From: karen Buckingham
Sent: 28/02/2025 11:17:37 AM
To: Council Northernbeaches Mailbox; Olivia Ramage
Cc: Michael Goodwin
Subject: TRIMMED: Objection letter - DA2025/0115 - 75 Bungan Head Road, Newport - prepared for Michael and Sharyn Goodwin of 75 Bungan Head Road
Attachments: Objection letter - 77 Bungan Head Road - DA20250115.pdf;

**Submission re: Objection to Development Application DA2025/0115
Alterations and additions to a dwelling house
77 Bungan Head Road, Newport, NSW**

Figure 1 – The two trees in the rectangular area are not on site or recorded in the Arborist Report

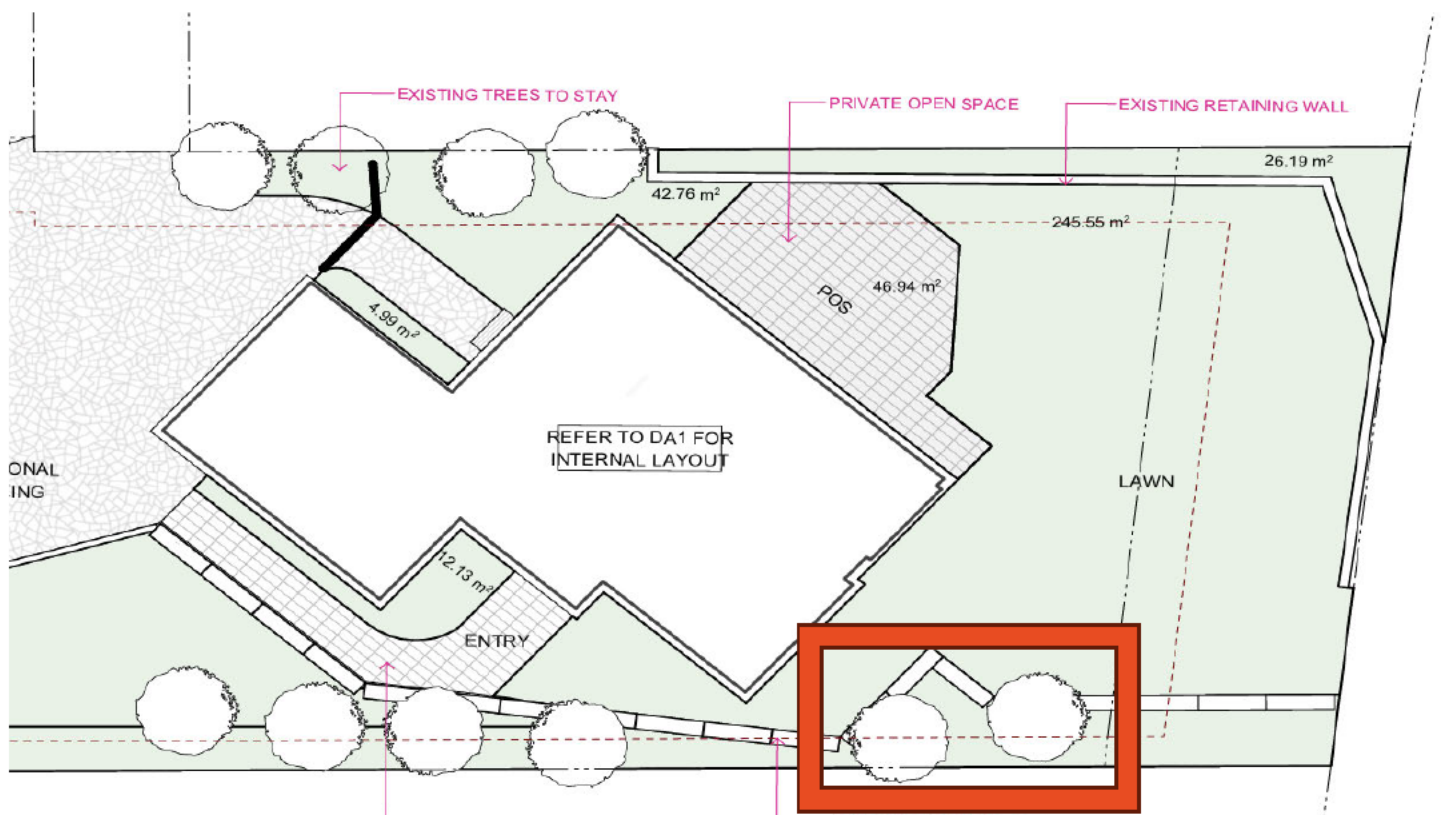
- Visual Impact Assessment (VIA) prepared by a suitably qualified professional.
- Erected surveyed height poles including the balcony structure at first floor and eaves above, to ground proof submitted plans and assist with the VIA.
- Certified elevational shadow diagrams to confirm solar impacts on the fenestration and balcony at 75 Bungan Head Road.
- Amended site analysis plan showing corrected north point.
- Amended plans – the two trees shown to the east of the southern boundary are not on the site or shown in the Arborist Report, as shown in Figure 1 below.
- Amended SEE where it references Mona Vale Locality DCP Controls rather than Newport Locality

Figure 2: Area Analysis plan with own annotation showing established building line

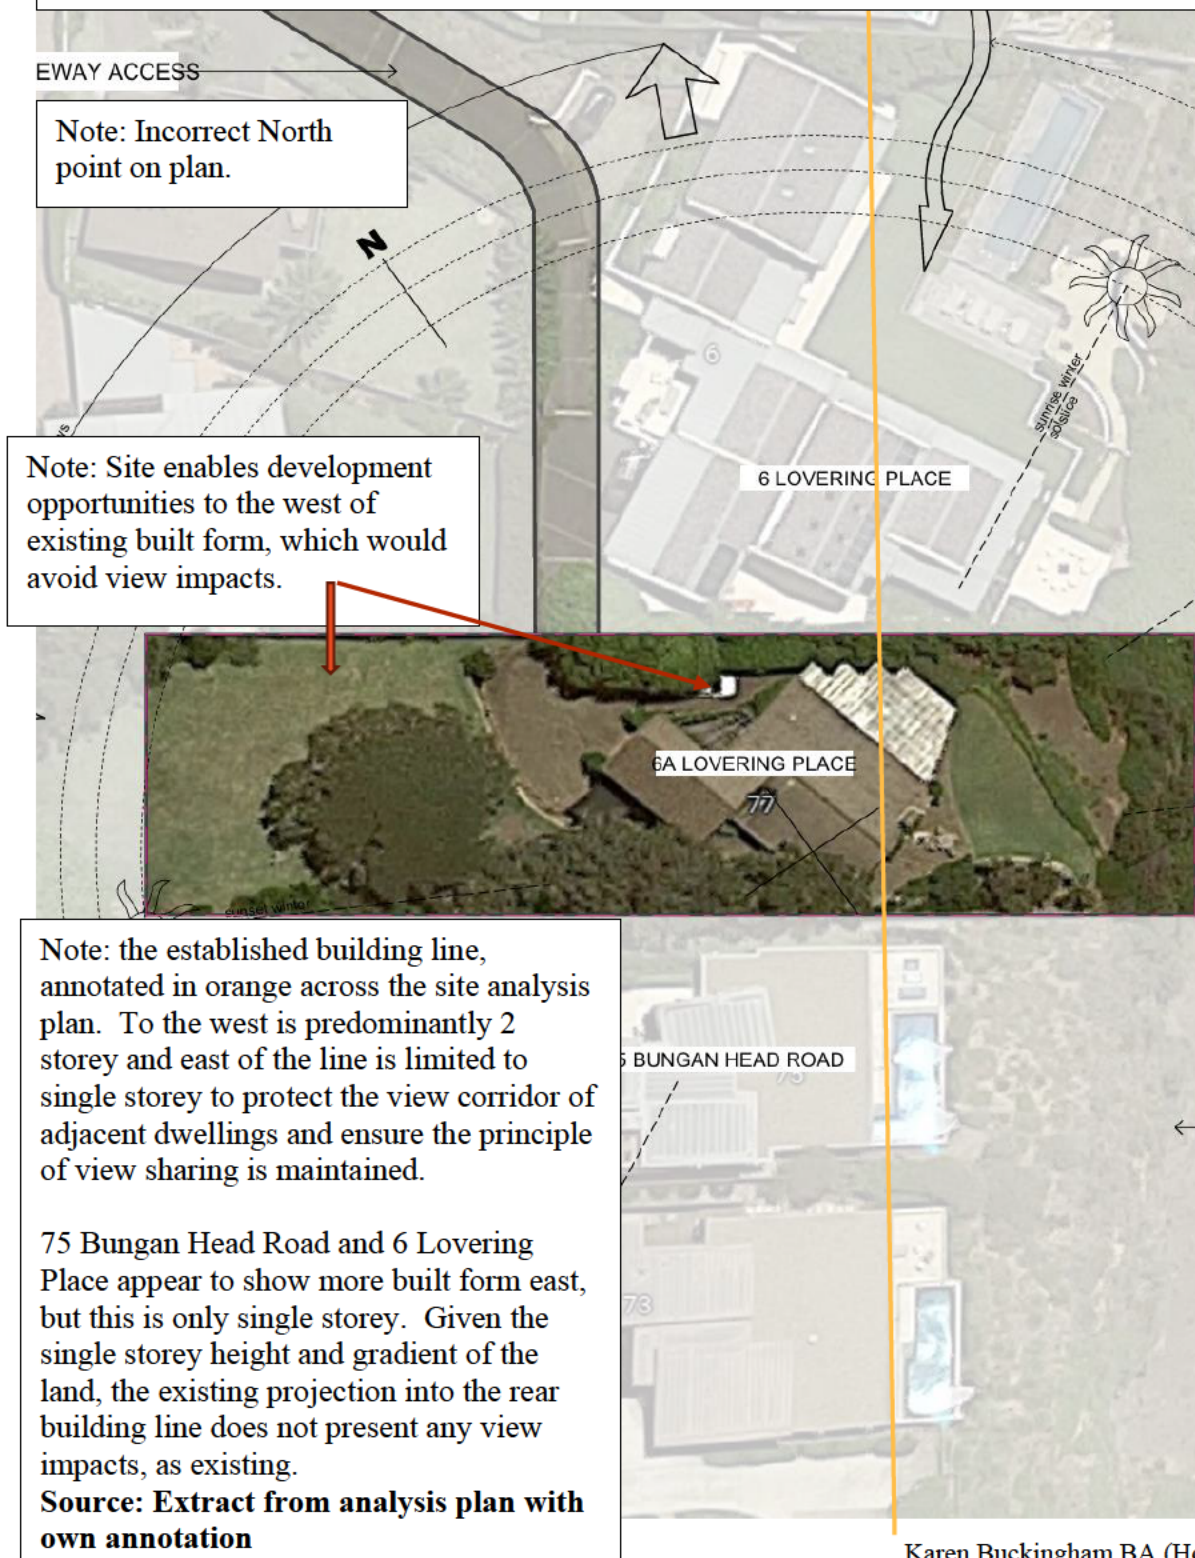
- The proposal does not comply with the design intent and outcomes of adjacent built form which respects view corridors by limiting to only single storey within 8m of the eastern setback (as shown on figure 2). Historically this has been Council's advice to ensure reasonable view sharing principles.

My client's property is in very close proximity to the subject site, off the side, southern boundary. As can be seen in figure 2, overleaf, my client's property and adjacent built form demonstrate a consistent building line where architectural designed homes include only single storey built form, pools or decks further forward than the line shown in figure 2. Built form has been designed as single storey beyond this point to avoid amenity impacts and enable view sharing. This is an important characteristic of the site and surrounding environment, both for retaining view corridors and respecting the scenic values of the environment

Figure 5 – Recommended design approach

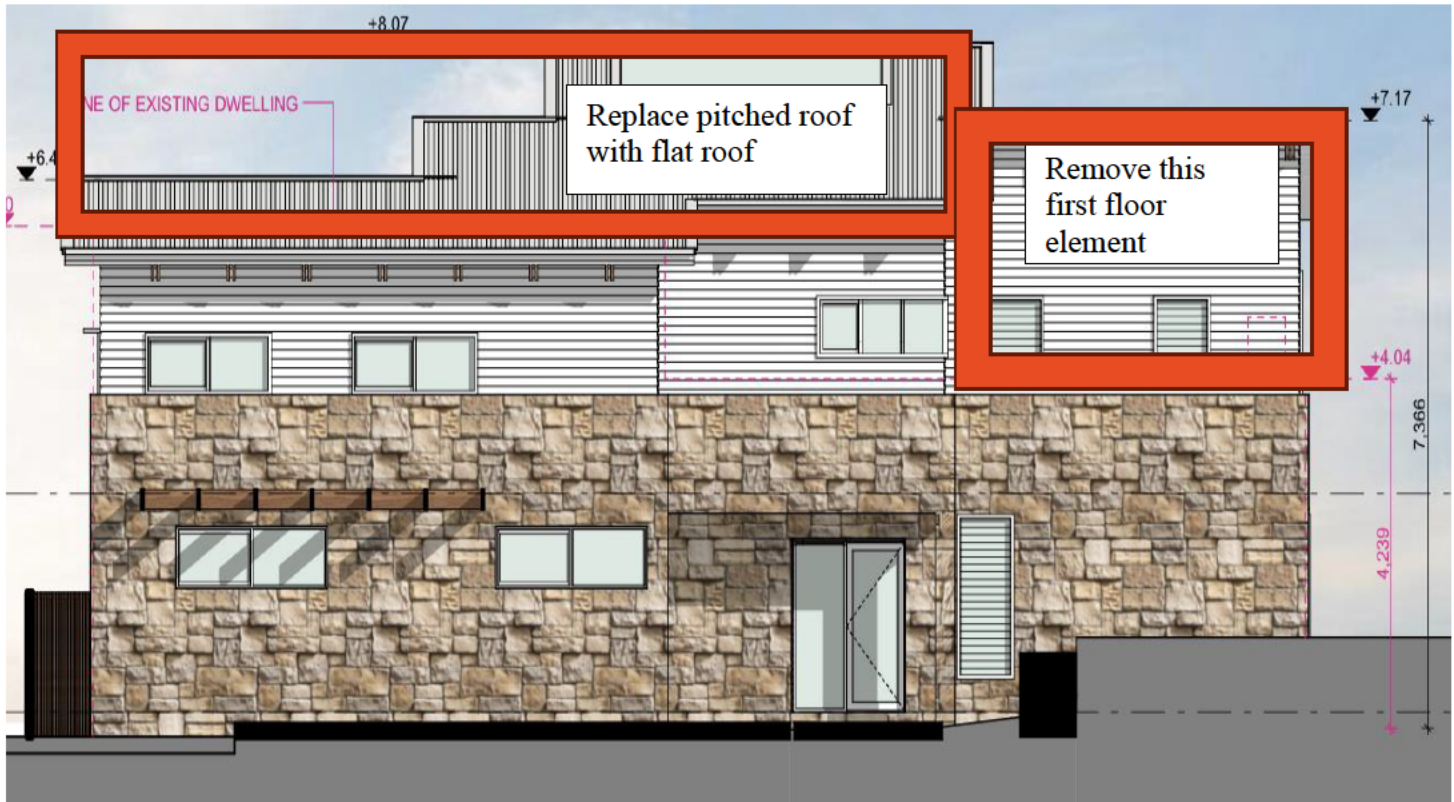
This is an important part of the fourth step. As shown in figure 6 of this submission, if the first floor accommodation serving the large Master bedroom, ensuite, sauna and walk in robe were removed and relocated further to the north/west of the site, a single storey element in this location would be a more skilful design and provide the applicant with the same development potential whilst reducing the impact on neighbouring amenity.

It should be noted that the level of accommodation as proposed is vast. It cannot be deemed as reasonable to impact on view sharing whilst providing for excessive floor space, particularly given that it could be in a less sensitive location on site. The same development potential and amenity could be achieved with the design approach shown in figure 5 and 6.

It is requested that amended plans be submitted to remove the first-floor addition from the southern elevation. Reconfigure the first-floor layout to relocate the master bed suite as shown in figure 6, overleaf.

- Refuse the proposed development given the objections raised in this submission unless significant amendments are submitted in line with the design approach at figure 5 and 6 of this submission.
- Remove the southern first floor elevation and relocate the master suite as part of a reconfiguration of the first-floor layout. From an assessment of the submitted plans, there is ample scope within the building design to accommodate these amendments and achieve an improved outcome and more sensitive design approach. There is ample room on the site, site area to the west of the site or closer to the northern boundary.
- Replace the proposed pitched roof with a flat roof over the remaining first-floor accommodation.

Figure 6 – Suggested opportunities to relocate Master suite and reconfigure layout

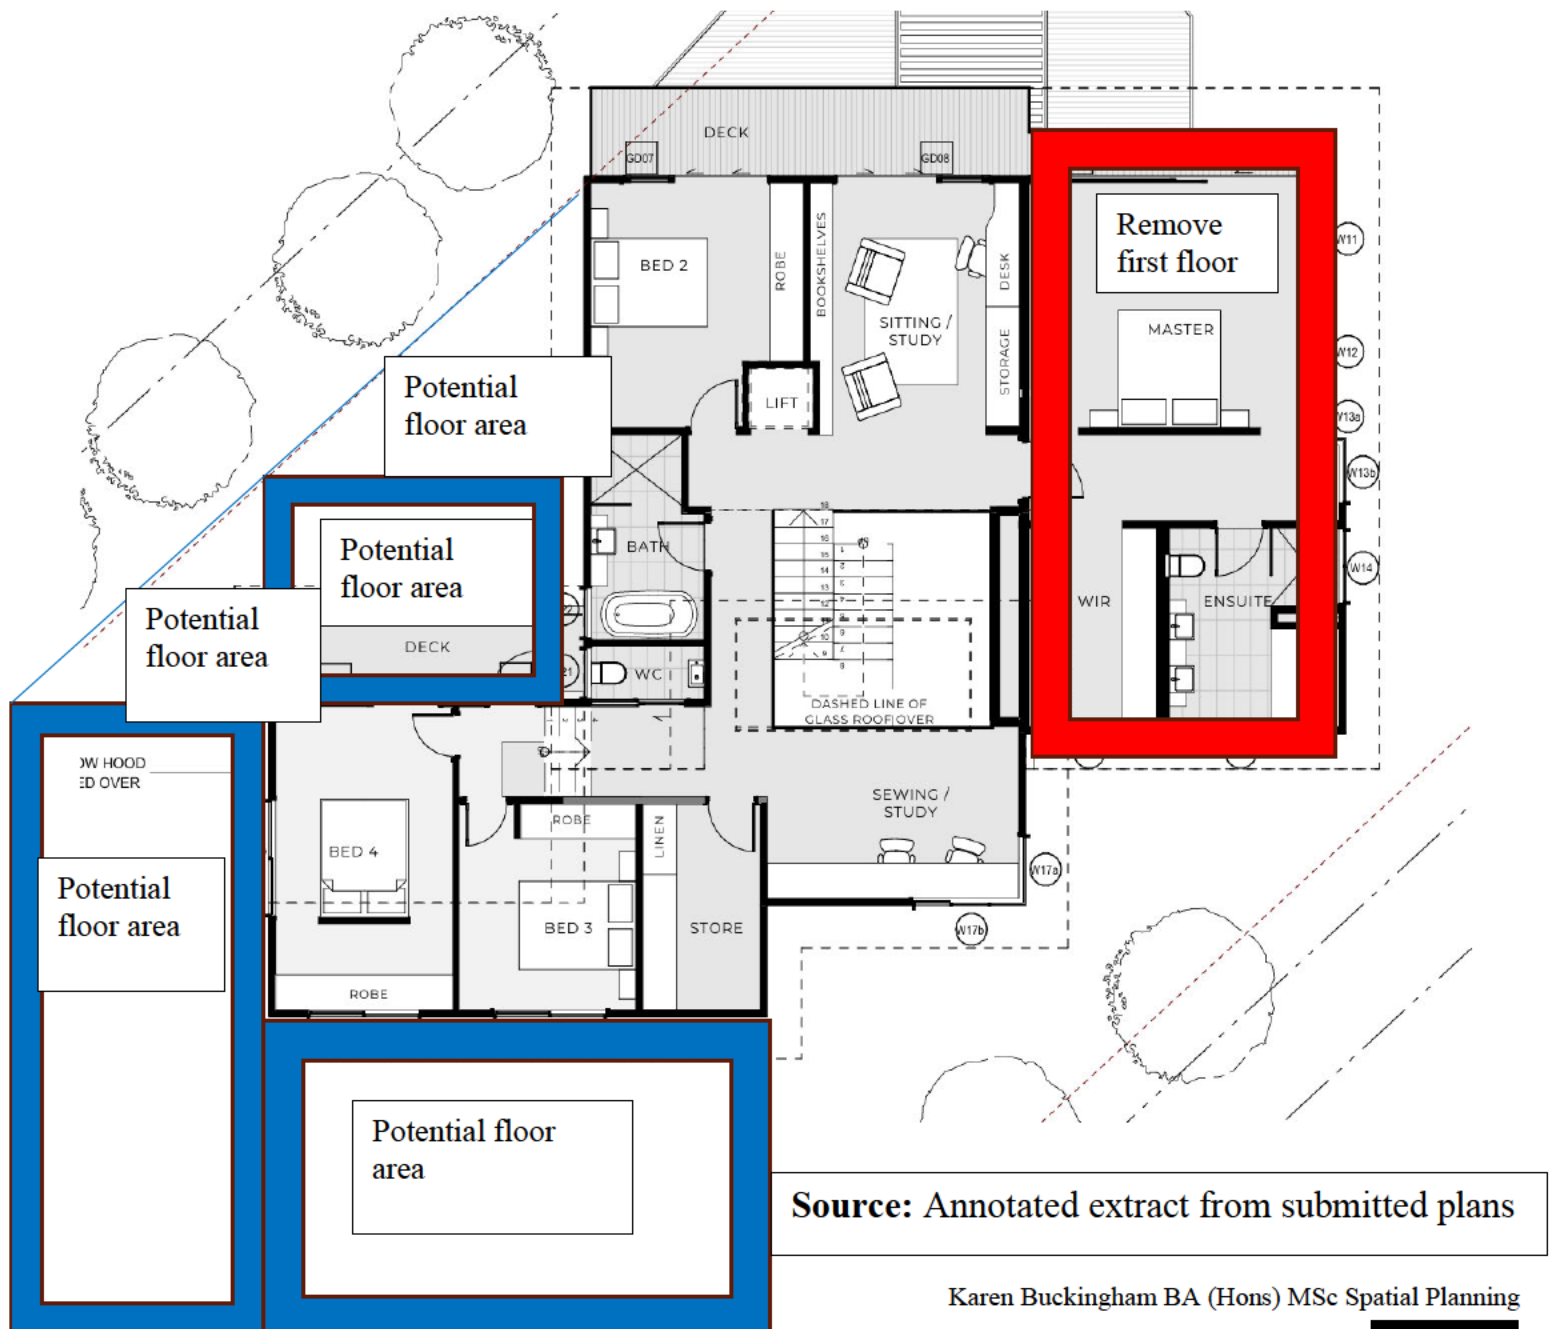
It is noted that in addition to the lounge area on the ground floor, the first-floor accommodation also includes a sitting room, study/sewing room, storeroom and 3 further bedrooms with bathroom and wc. The first-floor accommodation is extensive and provides ample opportunity for an amended layout. The remaining first floor accommodation should include a flat roof design to mitigate remaining impacts.

There is ample space on the 1336 sqm lot to place further development to the west of the site, or closer to the northern boundary where view loss and shade impacts would not occur due to the gradient and orientation. See site analysis plan and figure 2 of this submission.
